International Code Council

**ICC 500-2020 edition
Public Input Agenda with
Committee Votes and Public Comments
based on input received
on 2014 edition of the
ICC 500 Standard**

**For February, 2020
2nd Meeting – Teleconference**

2014 ICC 500-Standard Revision Proposals – Public Comments

Figure 504.1.1

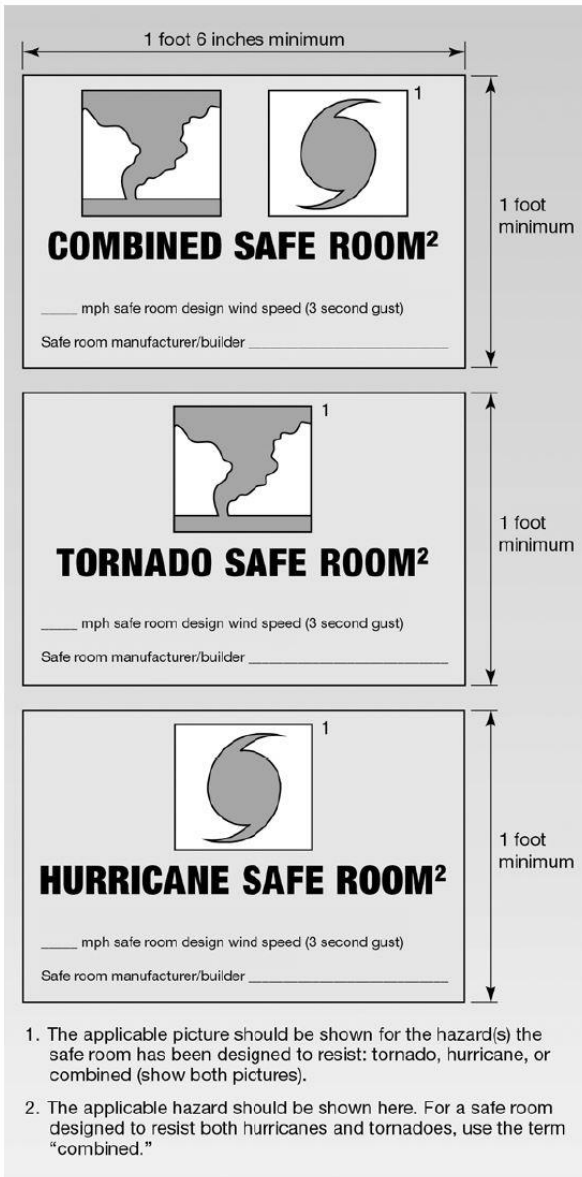
Staff Note: Modifications were also submitted for Commentary Figure 504.1.1 and 504.1.2

Add “Tornado Shelter Design Capacity: 1,500” to Figure 504.1.1.

Add “Tornado Shelter Design Capacity: 2,500” and “Hurricane Shelter Design Capacity: 1,500: to the top sign in Figure 504.1.2.

Add “Tornado Shelter Design Capacity: 400” to the middle sign in Figure 504.1.2.

Add “Hurricane Shelter Design Capacity: 2,000” to the bottom sign in Figure 504.1.2.

Committee Action: As modified (7-0 meeting) (12-0 electronic vote)

FIGURE ~~303.2~~ 303.1.1

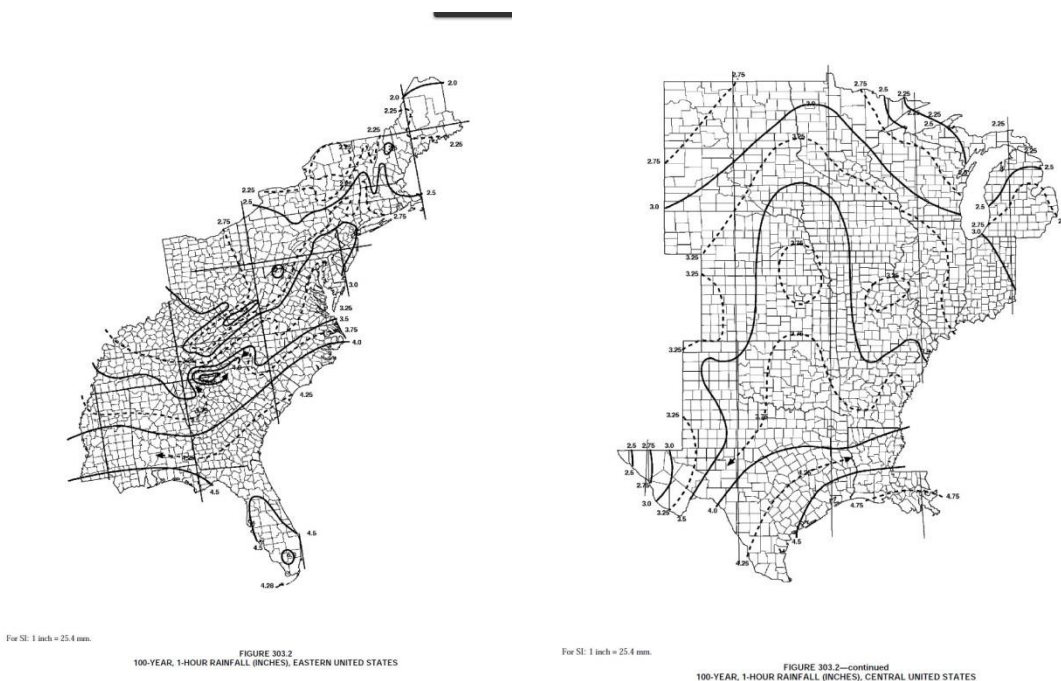
303.1.1. Rainfall rate. The rainfall rate shall be determined by adding 6 inches (152.4 mm) of rainfall per hour to the rainfall rate established from Figure ~~303.2~~ 303.1.1.

(Add figure for Western United States, Hawaii, Alaska and the American territories listed in ICC 500 Figure 304.2.1)

Reason: Figure 303.2 is referenced in Section 303.1.1 and not in Section 303.2. Section 303.2 has nothing to do with the figure.

FIGURE 303.2 303.1.1

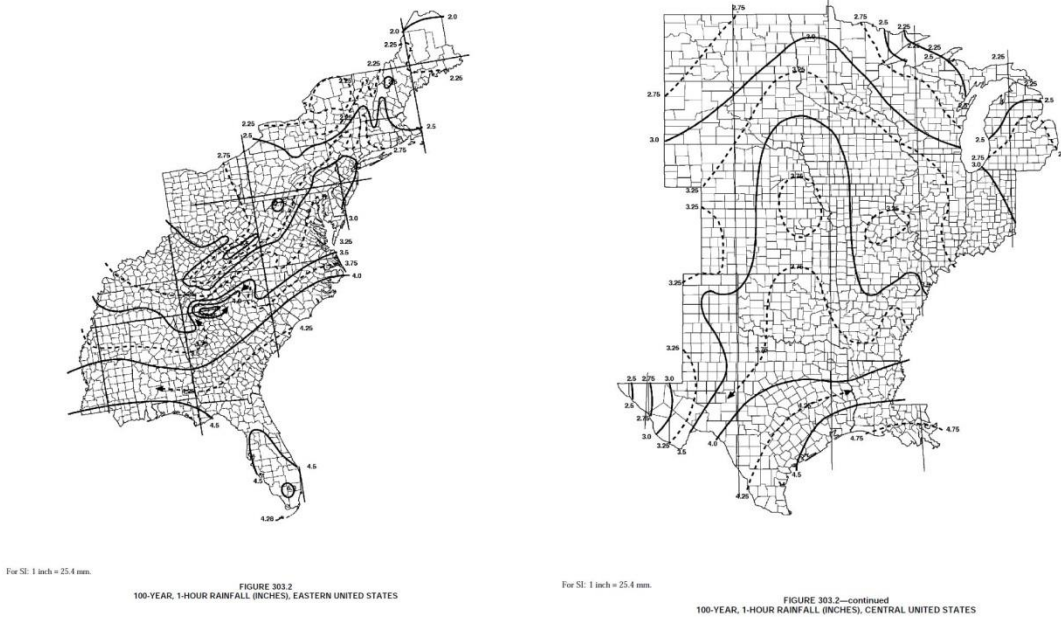
303.1.1. Rainfall rate. The rainfall rate shall be determined by adding 6 inches (152.4 mm) of rainfall per hour to the 100-year, 1-hour rainfall rate established from Figure ~~303.2~~ 303.1.1. For locations not illustrated in the figure, determine the 100 year, 1-hour rainfall rate from approved local weather data.

(Add figure for Western United States, Hawaii, Alaska and the American territories listed in ICC 500 Figure 304.2.1) 10-19-2018: See IS-STM-07-15-18 for Hawaii Map

Committee action: Approval as Further Modified		
	Affirmative	Affirmative with comment	Negative with comment	Abstain with reason
Schultz Vote:		x		
Your comment/reason: 303.1.1 Rainfall rate states “or from approved local weather data”. It is unclear who is the approver of this data?				
No revisions suggested.				
<p>303.1.1. Rainfall rate. The rainfall rate shall be determined by adding 6 inches (152.4 mm) of rainfall per hour to the 100-year, 1-hour rainfall rate. The 100-year, 1 hour rainfall rate shall be determined from Figure 303.1.1 or approved local weather data.</p>

Committee action: Approval as Further Modified		
	Affirmative	Affirmative with comment	Negative with comment	Abstain with reason
Scott Vote:		x		
Your comment/reason: Editorial – “Western” in Western United States map caption is spelled wrong (Westerm)				
Revise as follows:				
<p>FIGURE 303.1.1—continued 100-YEAR, 1-HOUR RAINFALL (INCHES), WESTERN WESTERM UNITED STATES</p>

Figure 304.2(2) SHELTER DESIGN WIND SPEEDS FOR HURRICANES

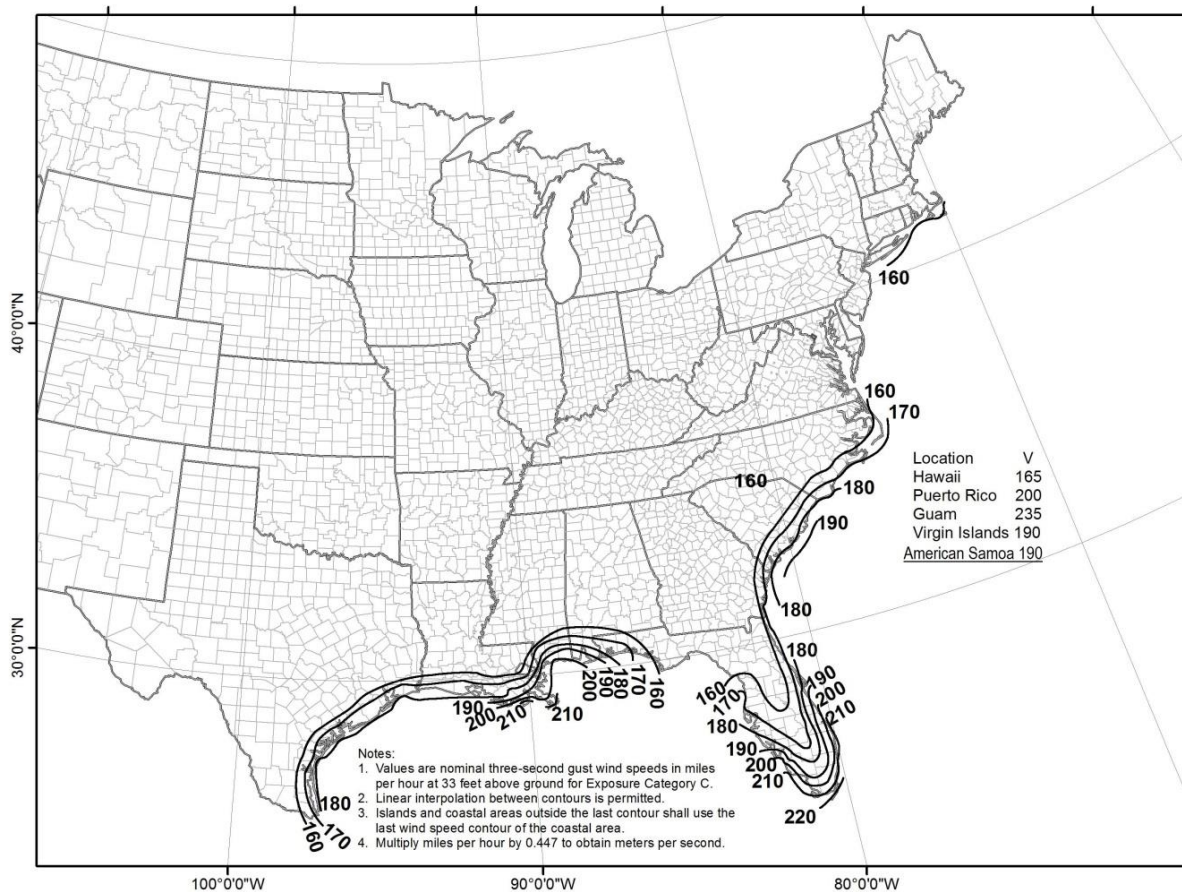
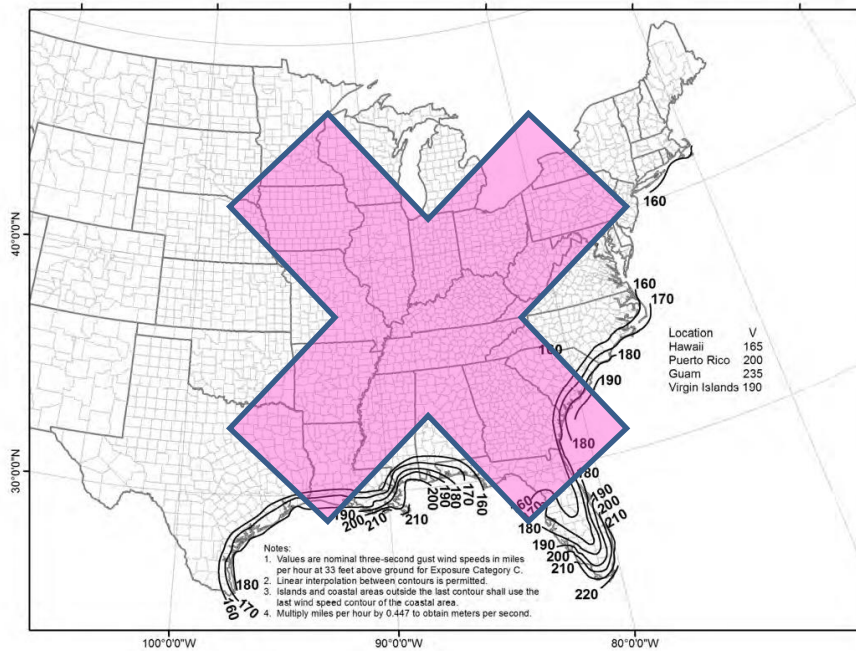
Reason: Currently Figure 304.2(2), the Shelter Design Wind Speeds for Hurricanes, does not specify a design wind speed for American Samoa where hurricanes are the greatest high wind hazard, and a 10,000 year MRI analysis is not currently available. From the ASCE 7 wind speed maps for 300, 700, 1700, and 3000 years, it turns out that the Virgin Islands and American Samoa wind speeds at each of these return periods are almost identical, meaning the hazard curves have a similar shape at the two locations. On the ASCE 7-16 Risk Category IV map,

American Samoa and the US Virgin Islands both have design wind speed of 180 mph. Therefore, the proposed wind speed for American Samoa is the same as the 10,000 year MRI wind speed that is currently used for the US Virgin Islands, 190 mph.

Committee Action: Approved as Modified (10-0)

Notes: Will also revise name for US Virgin Islands and add Commonwealth of the Northern Mariana Islands and American Samoa to full map. ARA will provide revised map for standard.

Rotate maps to landscape in final draft.

FIGURE 304.2(2)
STORM SHELTER DESIGN WIND SPEEDS, V , FOR HURRICANES

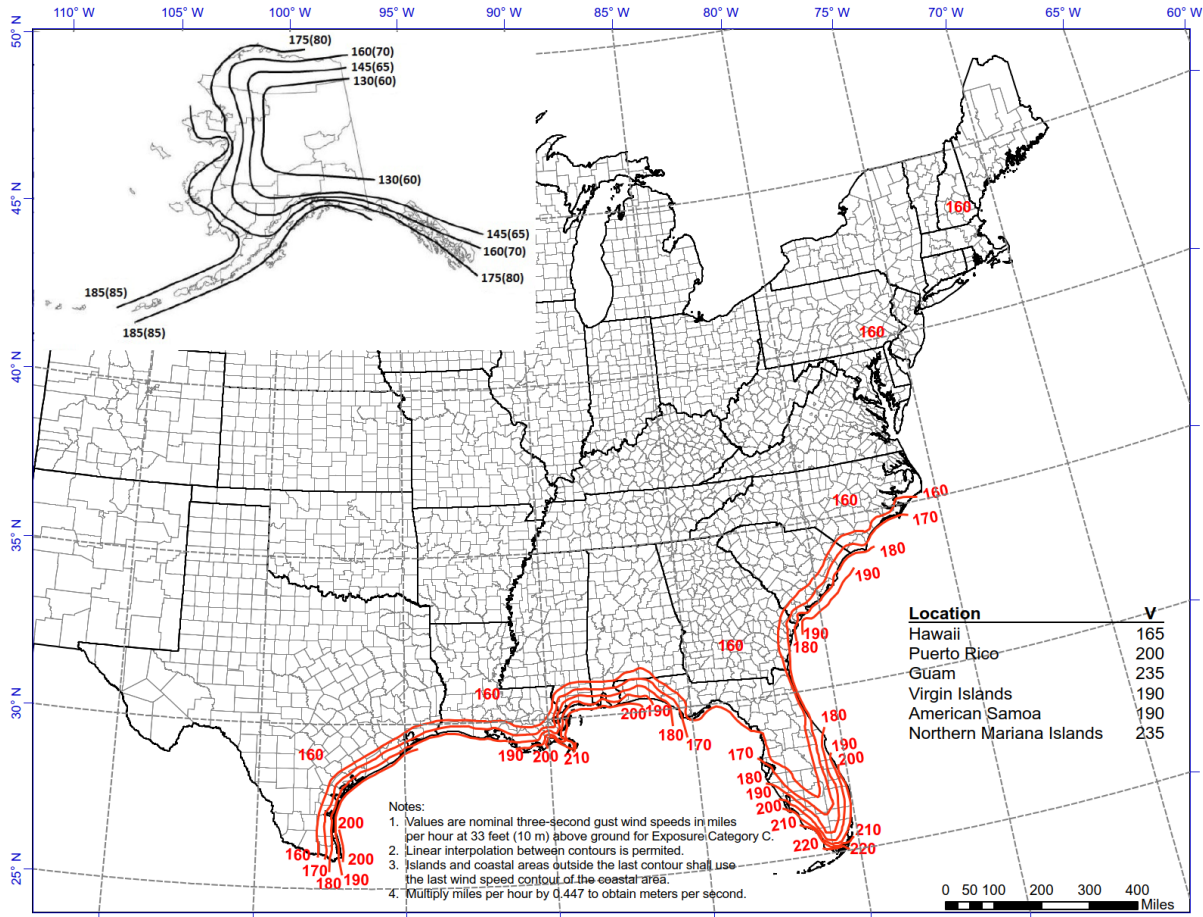
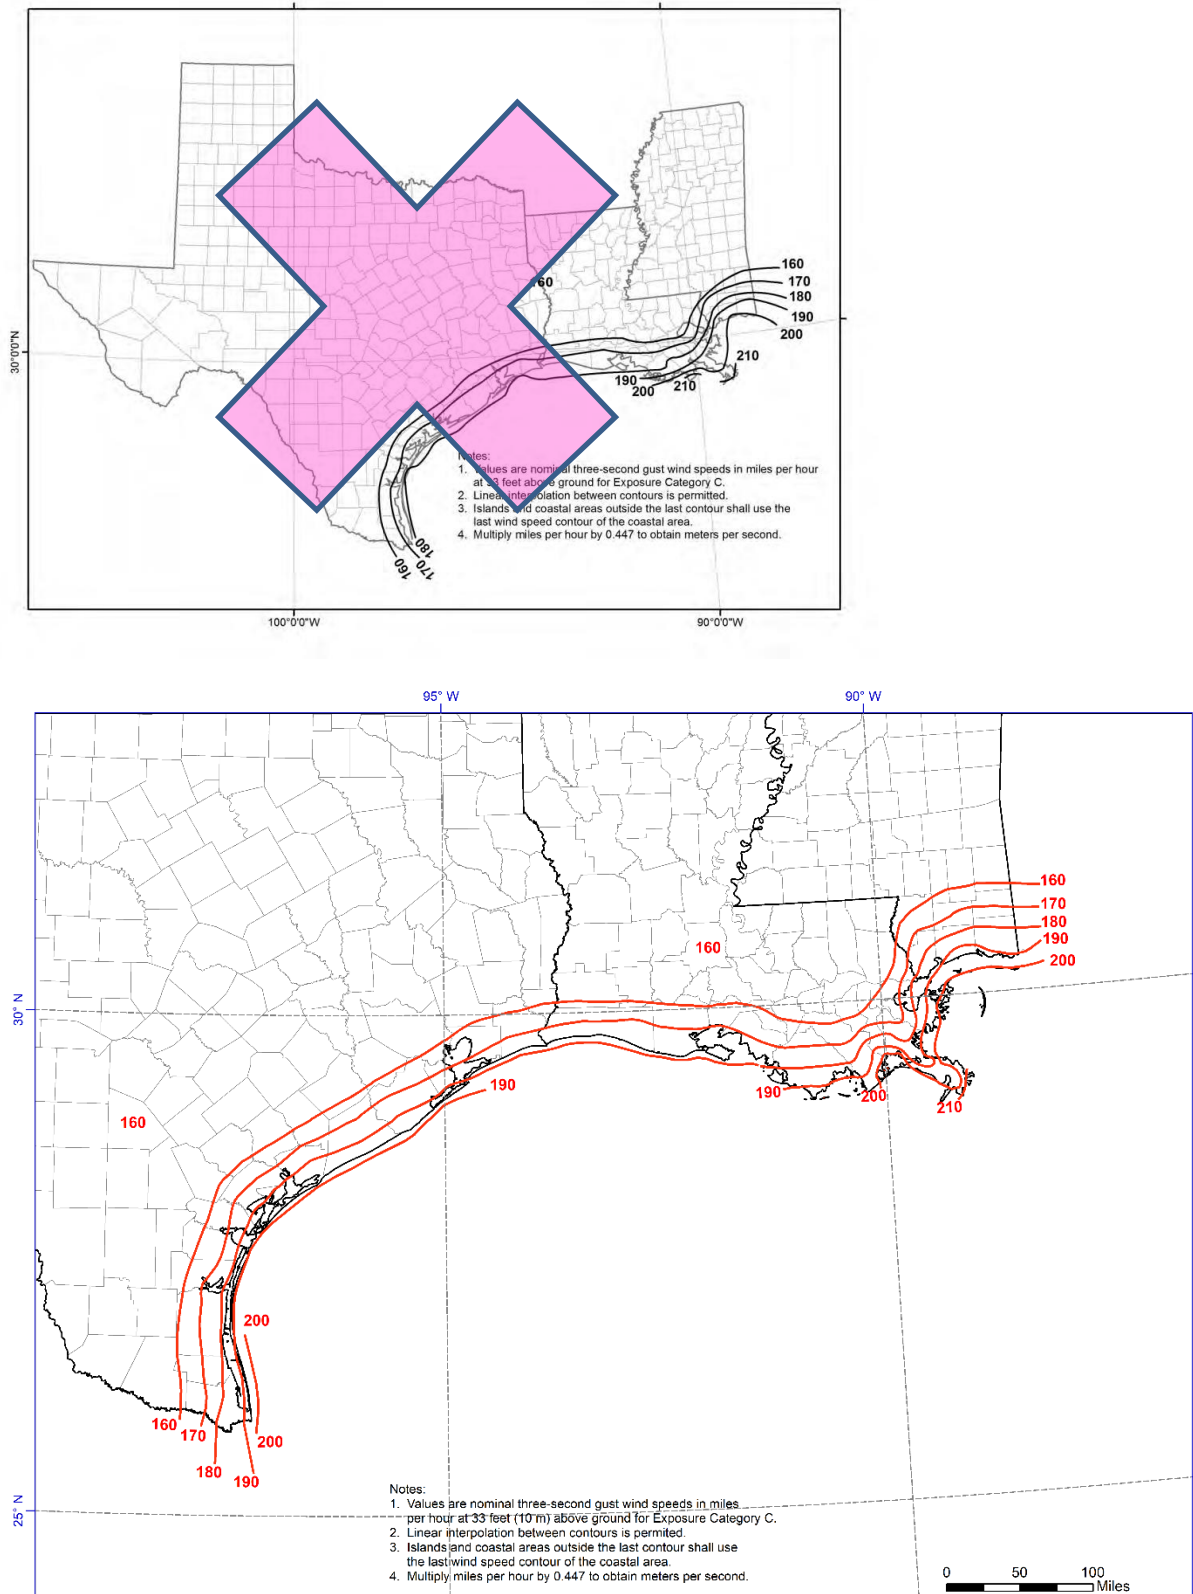
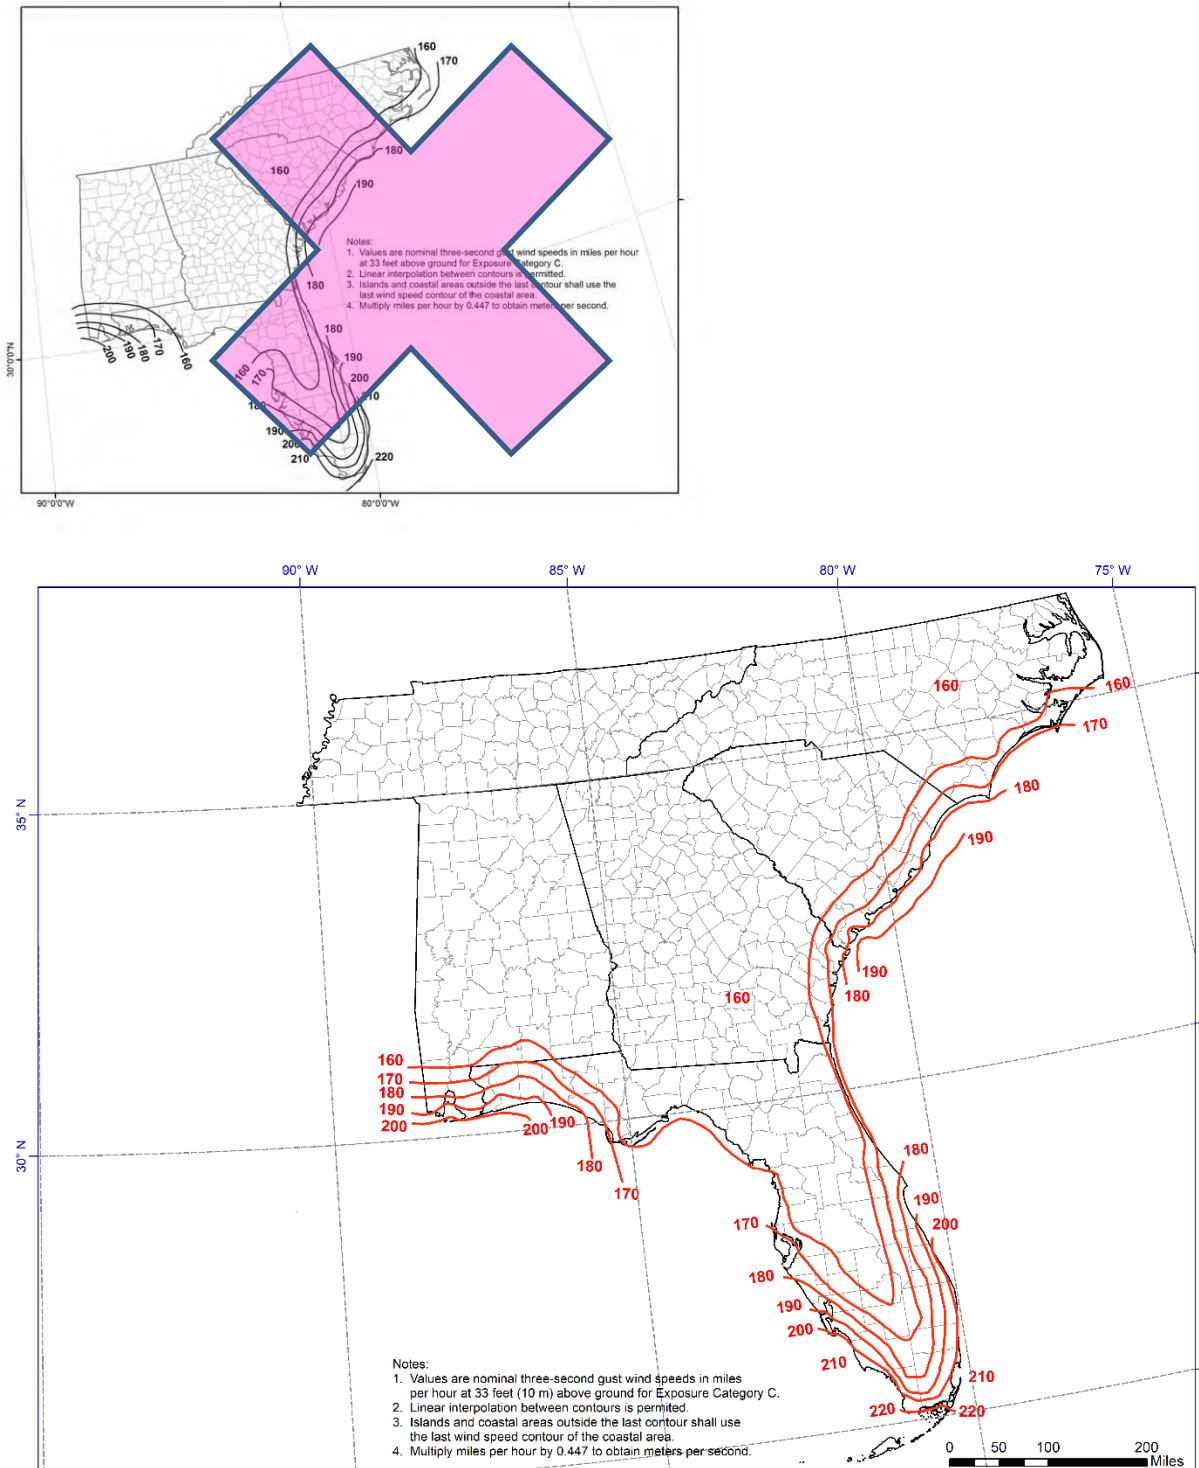
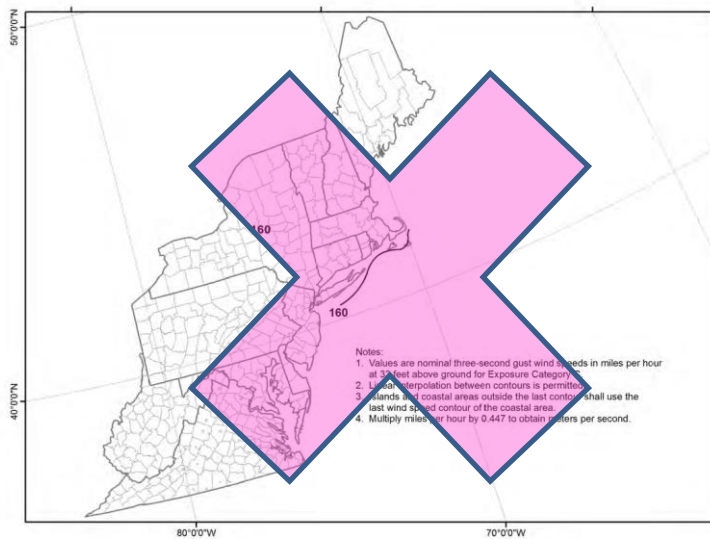
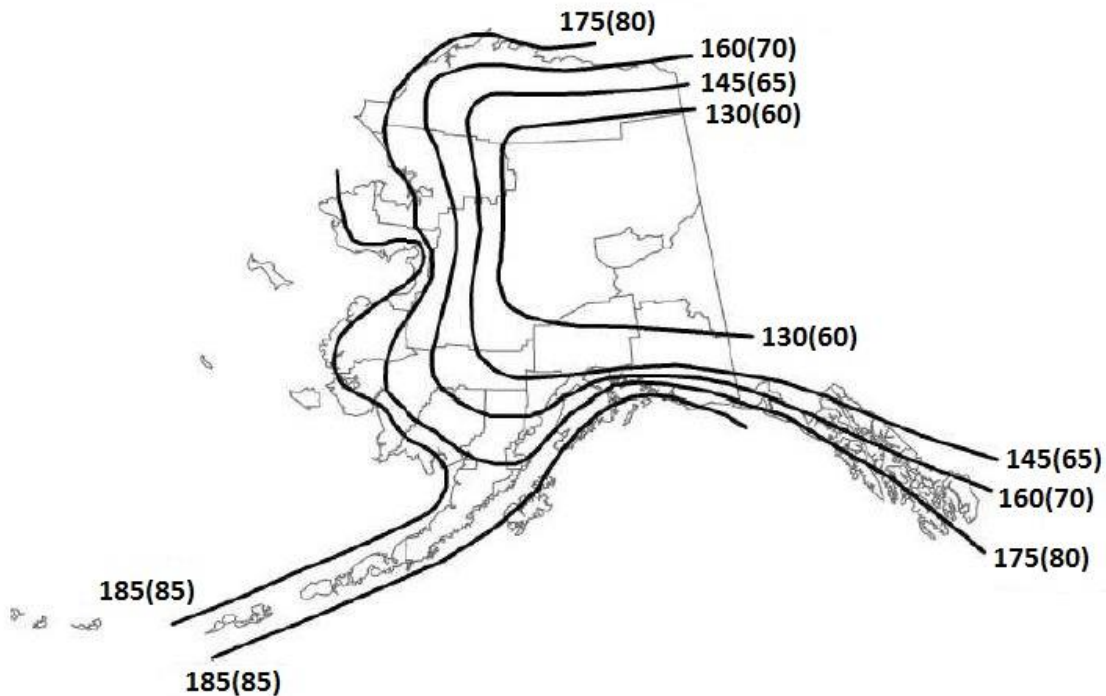
Delete four current maps and replace with the following

Committee Reason: Revised maps to coordinate with latest information for hurricane winds. Add Alaska because that state is affected by hurricane winds. Full list of islands is needed.
